City of Arvada

City Council Agenda

JUNE 3, 2024

SUBJECT: R24-059, A Resolution Authorizing Change Order No. 2 to the Construction Management Agreement For Pre-Construction & Construction Services for the Meyer's Pool Replacement Project

1 NORTH PRECAST WALL INTERIOR ELEVATION
1/8" = 1'-0"

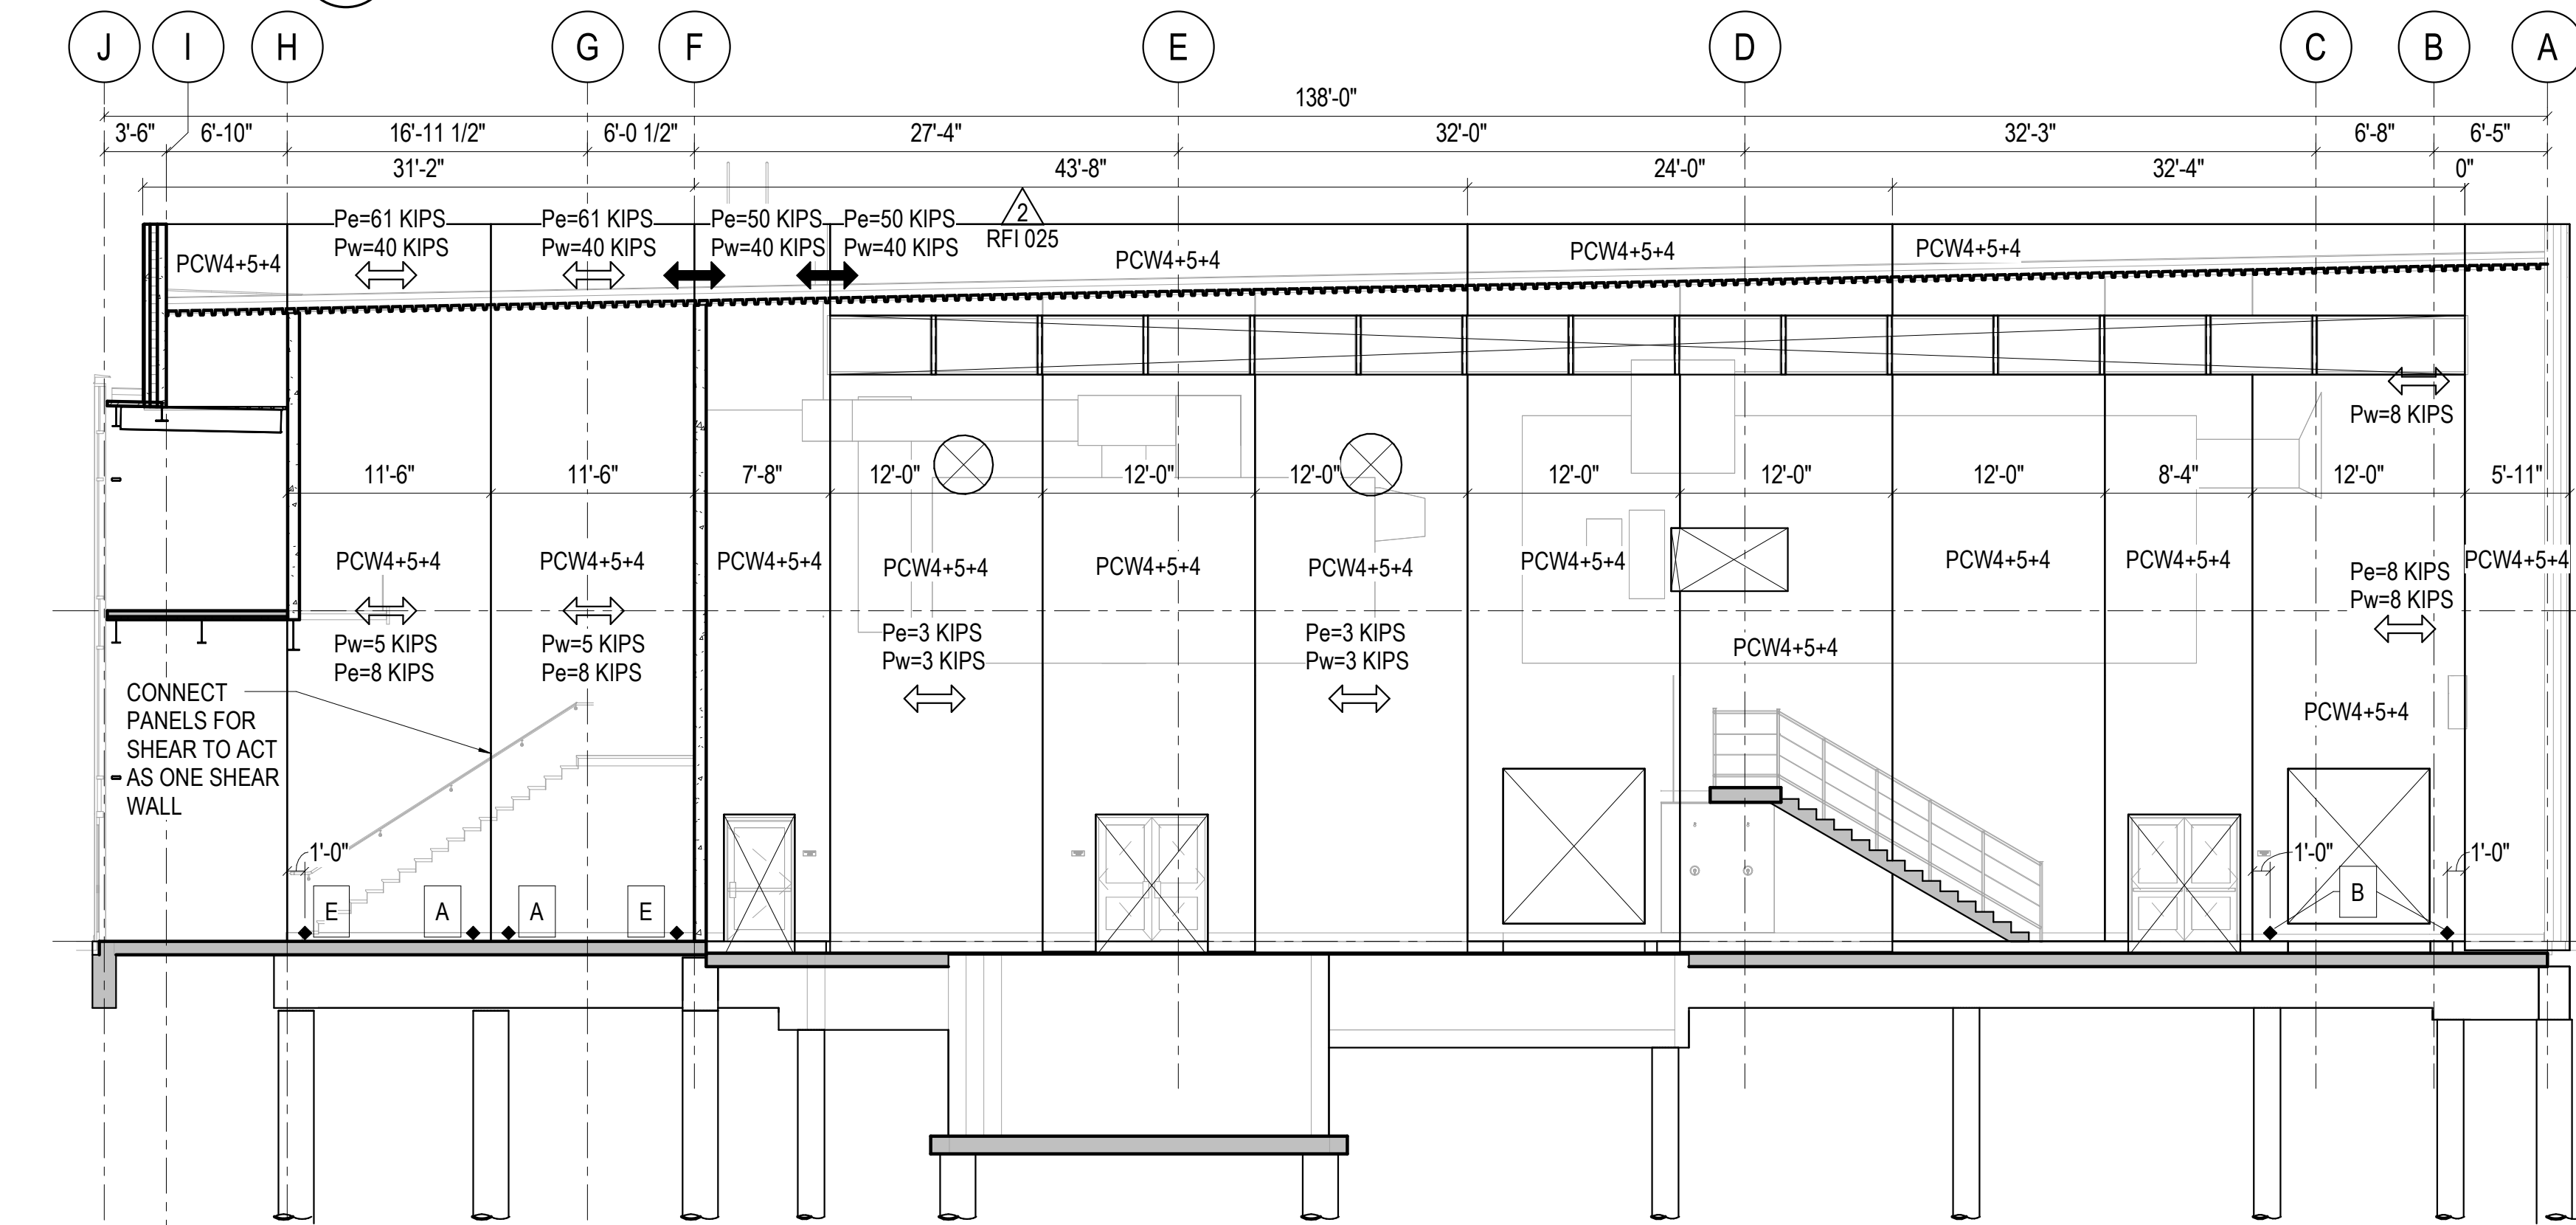
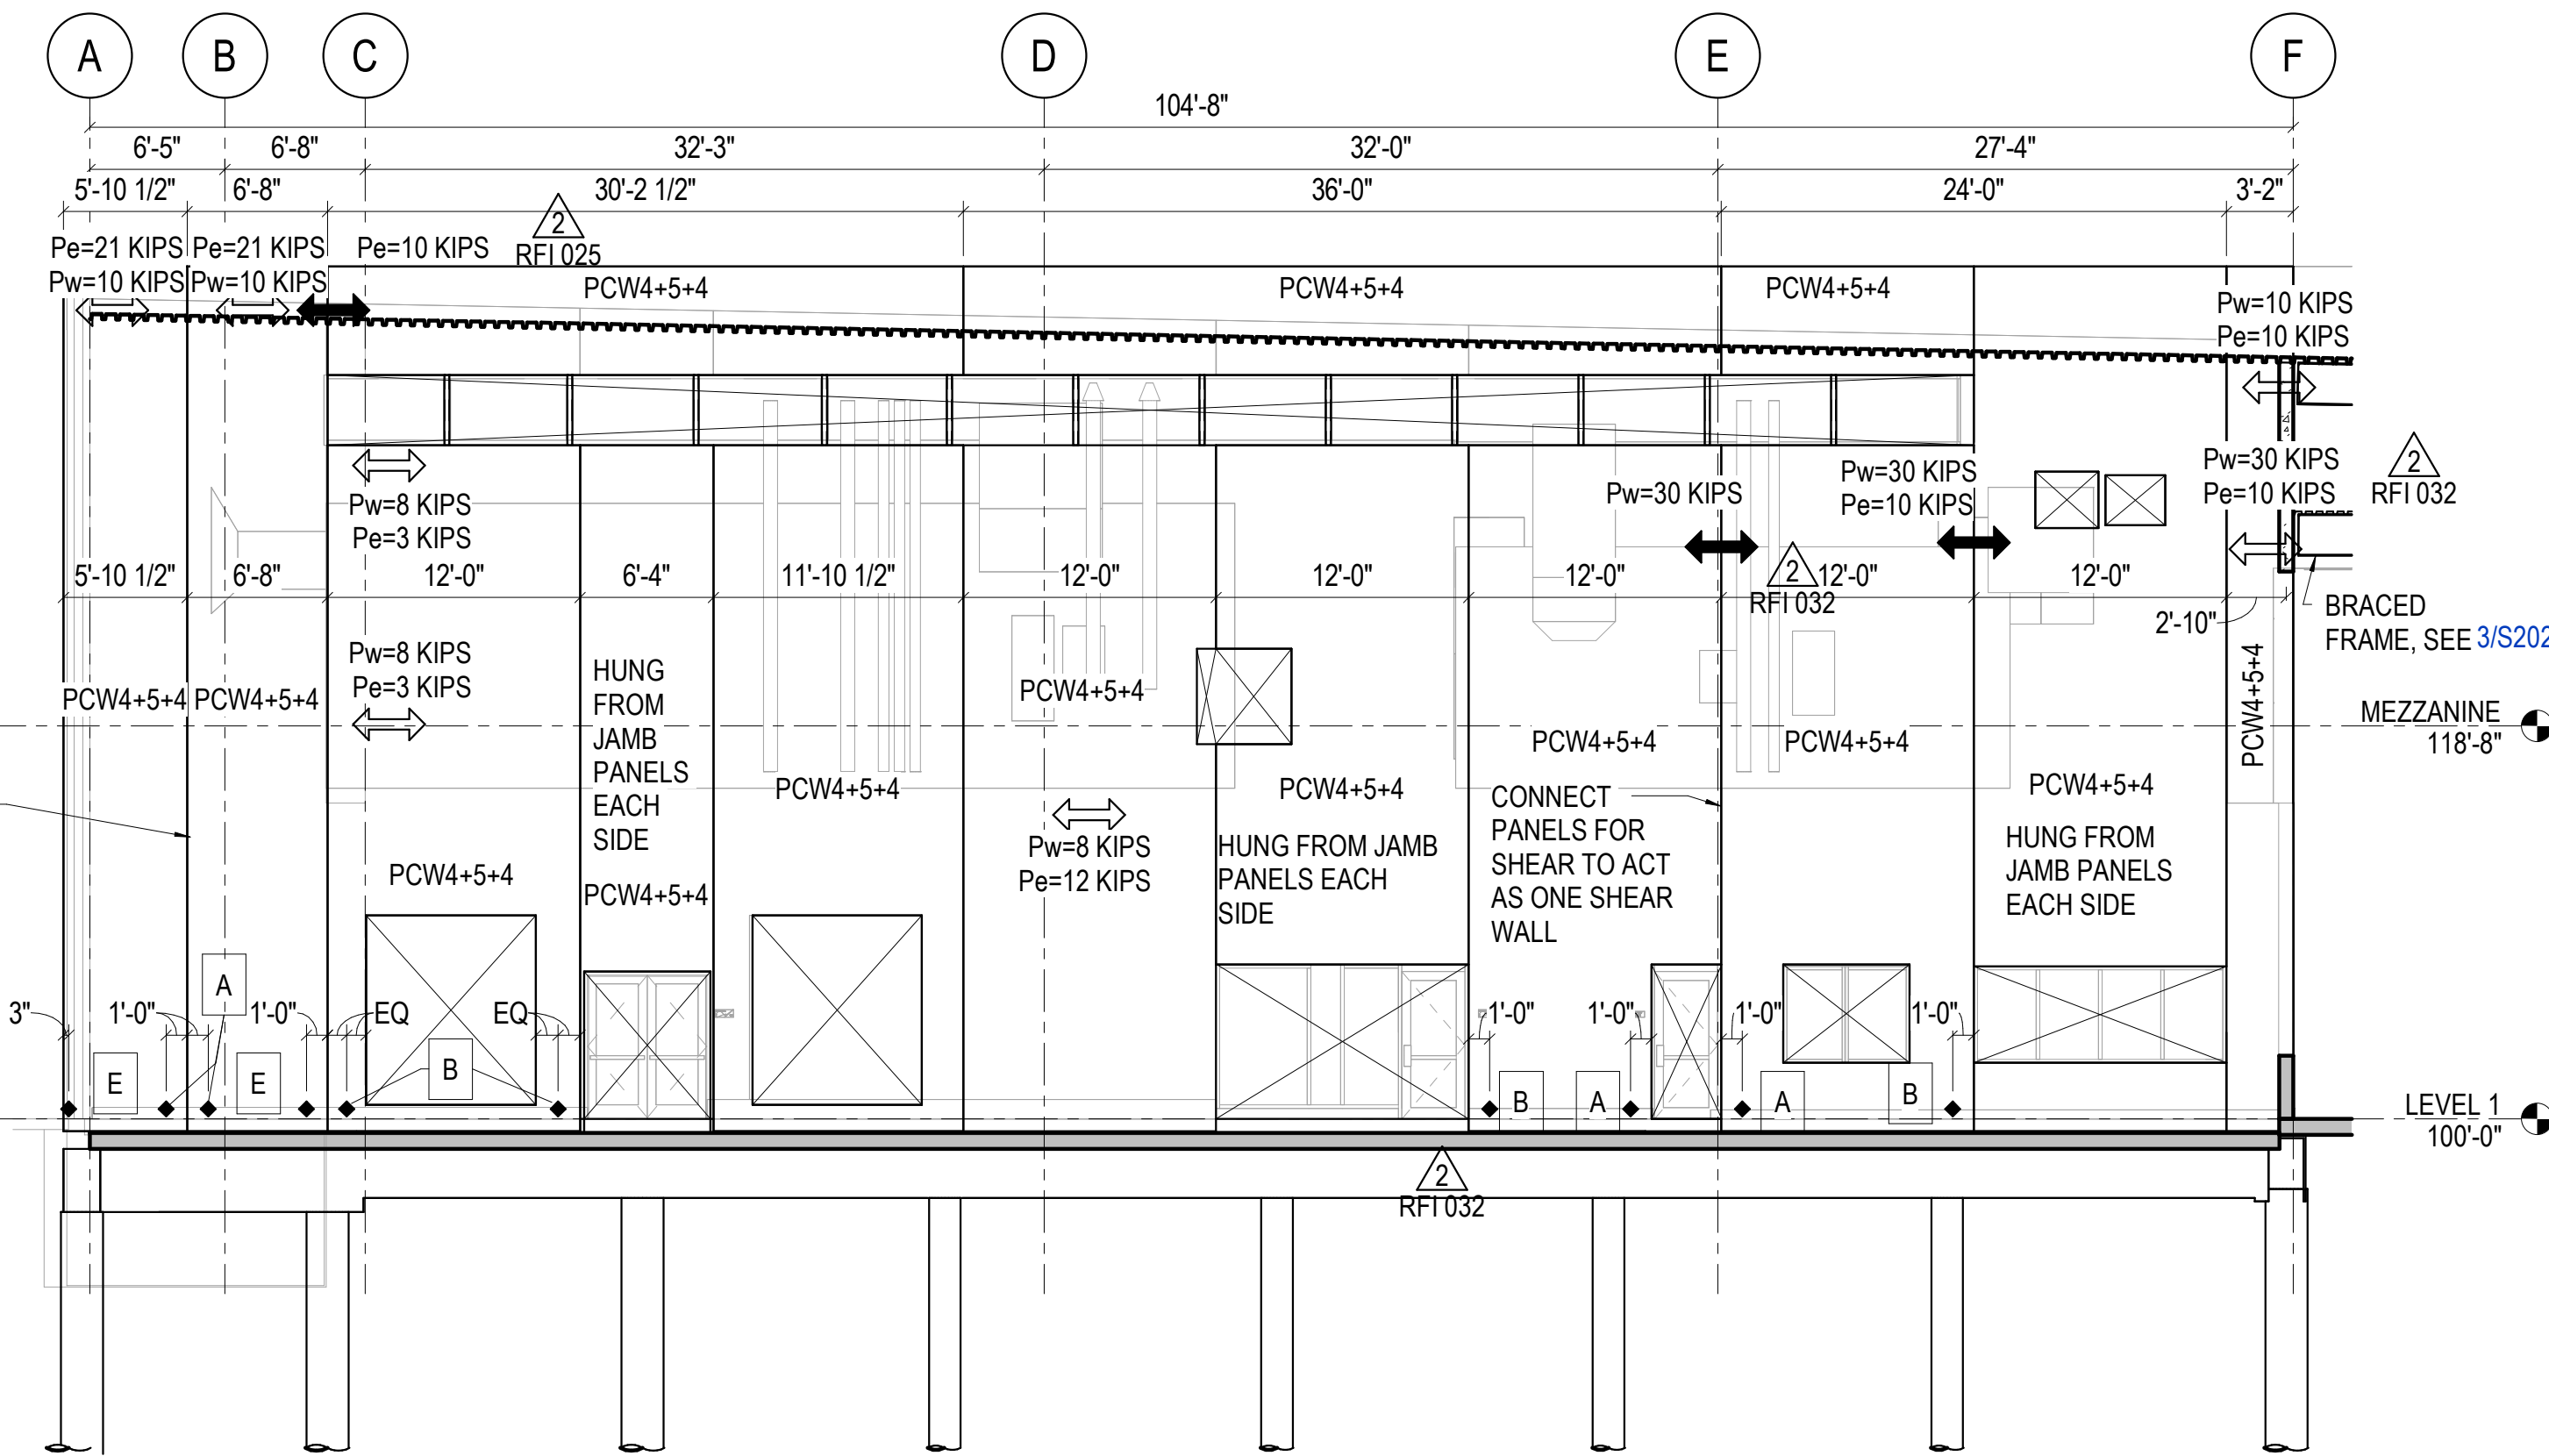
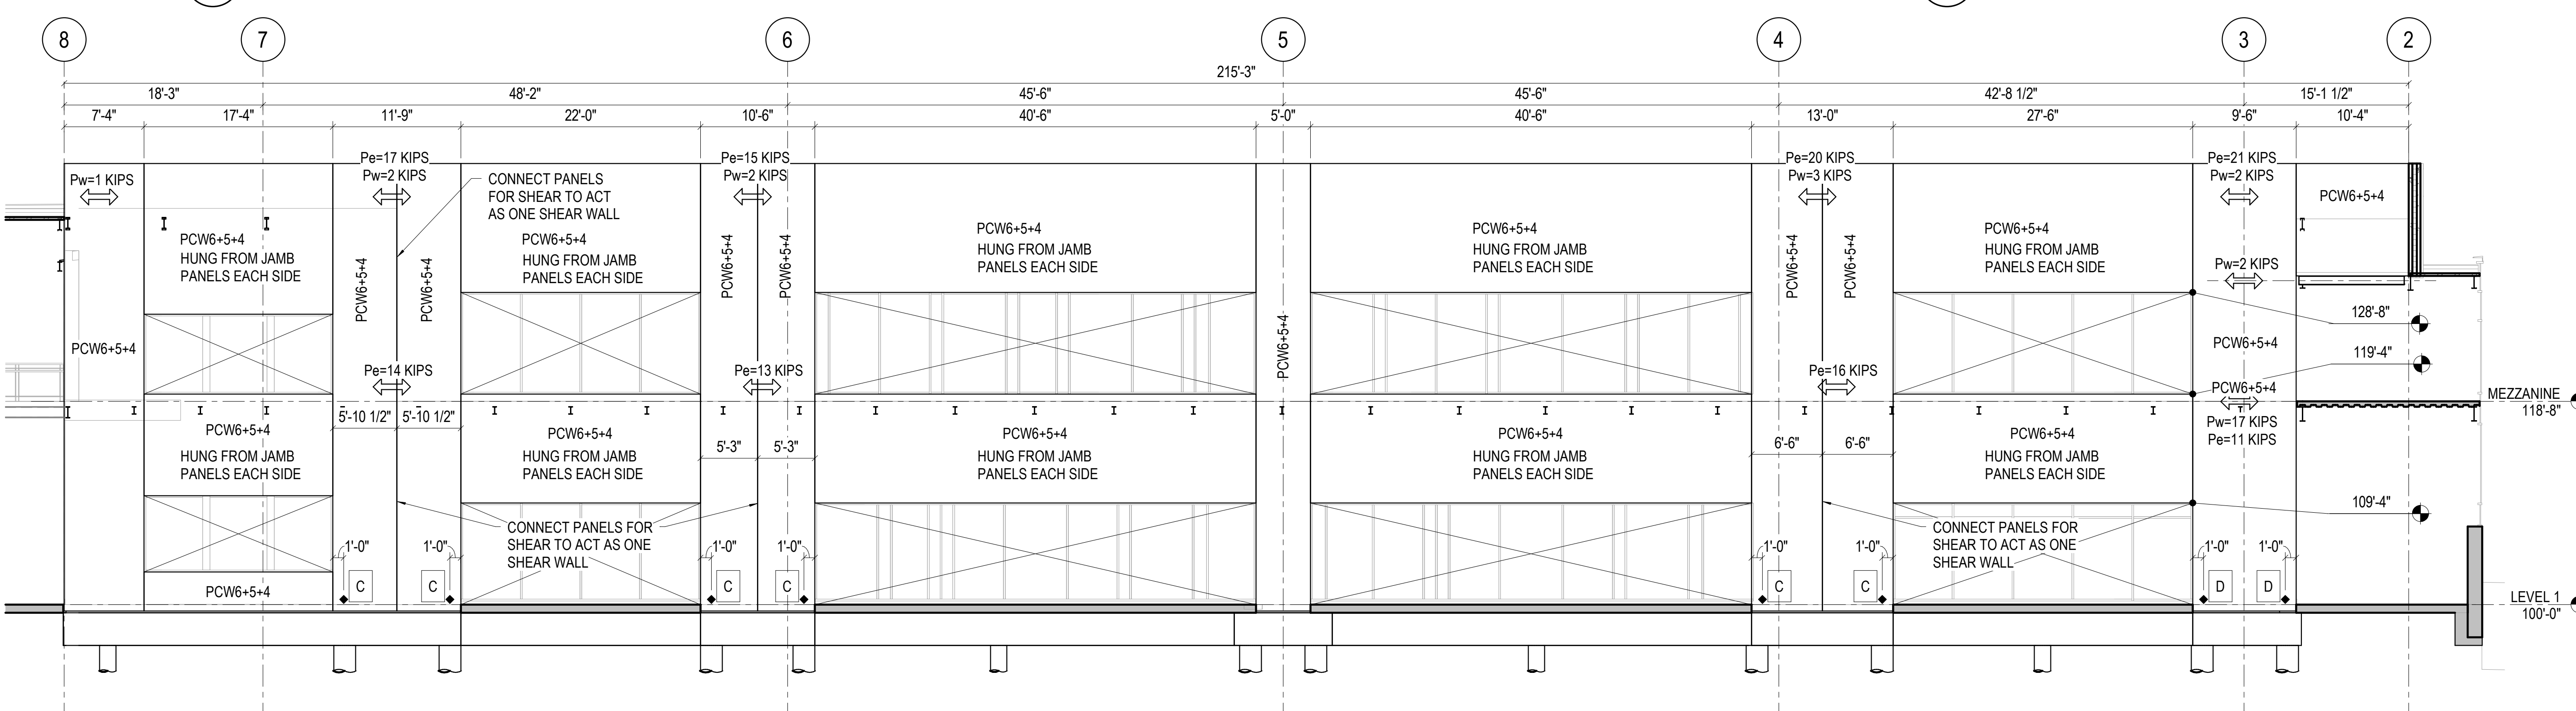
SHEET	DESCRIPTION
A210	Detail 4 – Pool West elevation: Revise wall tile at pool deck showers as indicated.
A405	Detail 1 – Mech and Pool Storage Enlarged Plan-1, PROVIDE location of pool deck shower plumbing.
A409	Various Details – PROVIDE dimensions for Diving Tower as indicated.
S110A	Plan revisions – Revised location for 1M spring board platforms, RFI 110 and 130 Revisions to CMU walls.
S110B	Plan revision for RFI 130 – CMU Wall callout.
S120A	Plan Revisions – RFI 110 CMU wall revision, RFI 149 steel beam connection detail revision.
S130A	Plan Revisions – RFI 110 CMU wall revision,
S205	Plan views 3 and 4 – Revised platform layout and slab dimensions. Detail 5 - Additional information provided to support the dive platform structure.
S206	Detail 12 – Revised platform layout and slab dimensions. Details 13 and 15 – revised dive platform slab thickness.
S211	Elevation 1 – Revised precast wall thicknesses to match precast shop drawings.
